**SUBJECT: RECALL R10RM REAR INNER BULKHEAD PANELS FMVSS  
221 JOINT STRENGTH NONCOMPLIANCE**

# Rear Inner Bulkhead Panel Joint Strength Noncompliance

**Models Affected: Certain 2010 Model Year All American (D3RE) Rear Engine School Buses**

**Street Side**

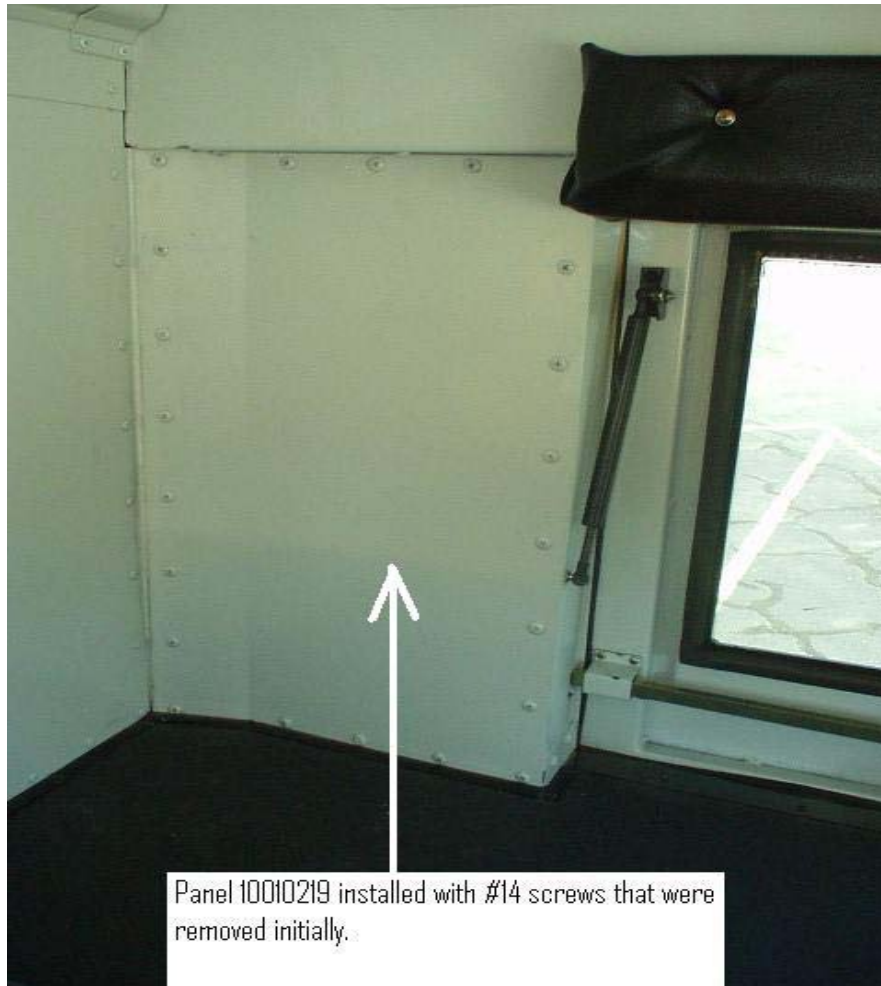
Adhesive required to meet FMVSS 221 Joint Strength requirements may have been omitted on rear inner bulkhead panels.

Remove right rear (curbside) inner bulkhead panel, apply adhesive and reinstall panel.  
Remove and discard left rear (driver's side) panel, apply adhesive and install new panel along with new access panel.

1. Remove panel without access panel and discard. Retain the screws. Sand the paint down to bare metal on the rear structure where the adhesive will be applied. Sand ½ inch on each side of screw holes. Be careful not to sand area that will not be covered by new panel. Wipe sanded area clean before installing adhesive.
2. Apply a ¼ inch bead of Magnabond adhesive in the center of the mating surfaces for the close-out panel along or near the screw line.
3. Install new panel (10015934) with #14 screws removed previously. Be sure to clean off any excess adhesive immediately before it has time to start curing.
4. Install access panel (10013015) with (6) 01164821 #10 x .75 screws.
